### **REMARKS**

### **Amendments to the Drawings**

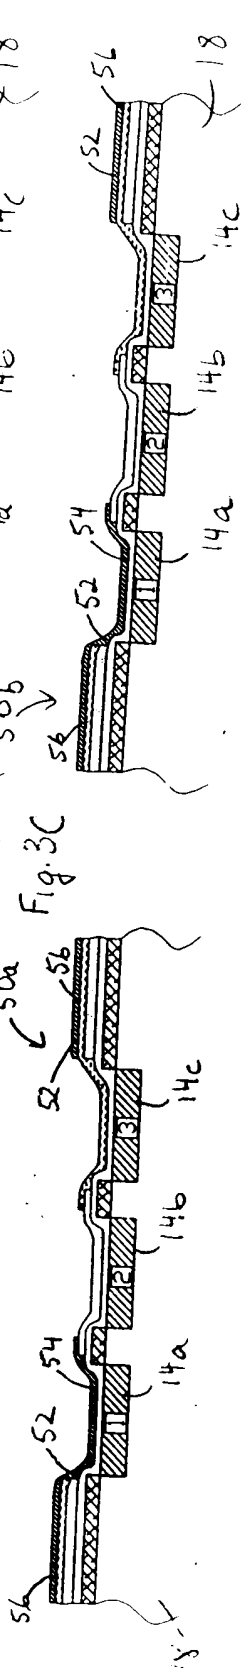
Figure 3A has been amended to include element 20 pointing to the topography, analogously to figure 2A.

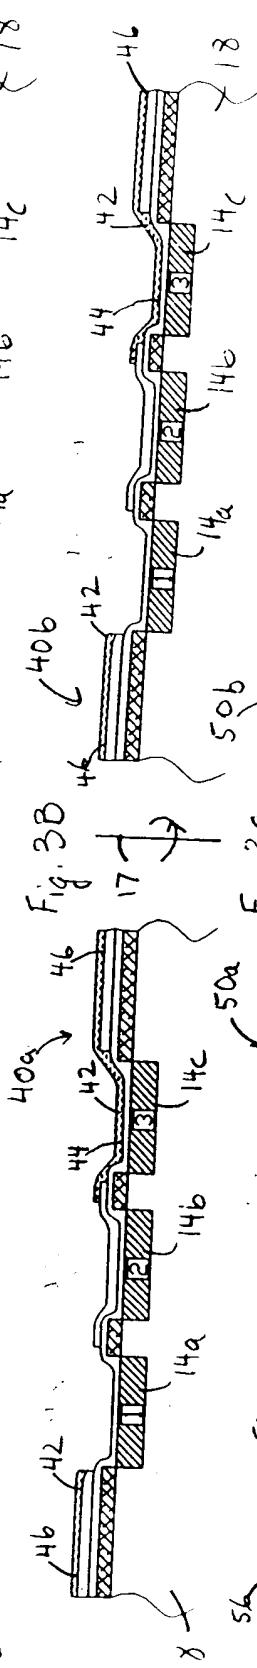
Figure 3B has been amended to include element 38 pointing to the sensor areas 38 overlying sensors 14a and 14c, according to page 10, line 10.

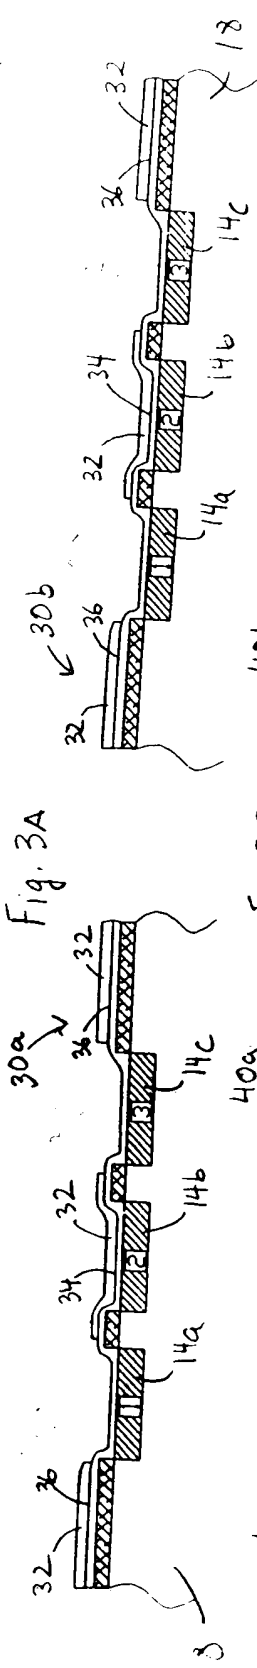
Figure 3C has been amended to include element 48 pointing to the sensor areas 48, overlying sensors 14a and 14b, according to page 12, line 23.

Fig. 3D

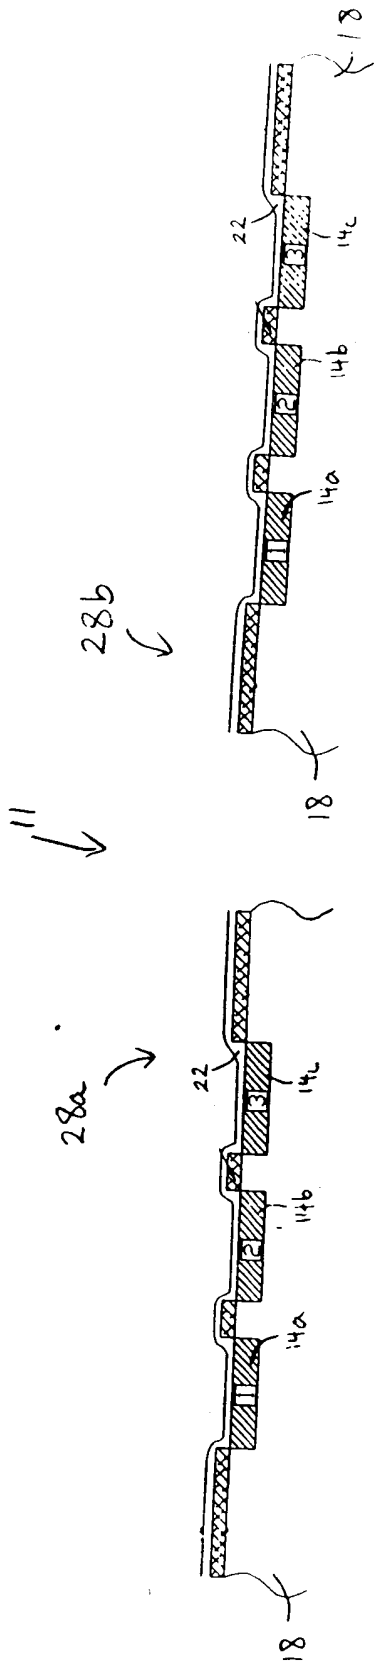
Figure 3D has been amended to include element 58 pointing to the sensor areas 58, overlying sensors 14b and 14c, according to page 14, lines 2-3.

Fig. 4C

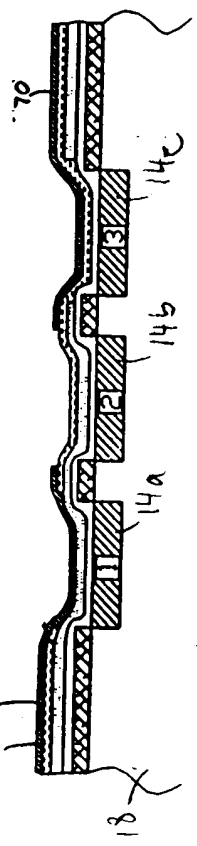
Figure 4C has been amended to include element 64, a yellow filter, according to page 15, line 6.
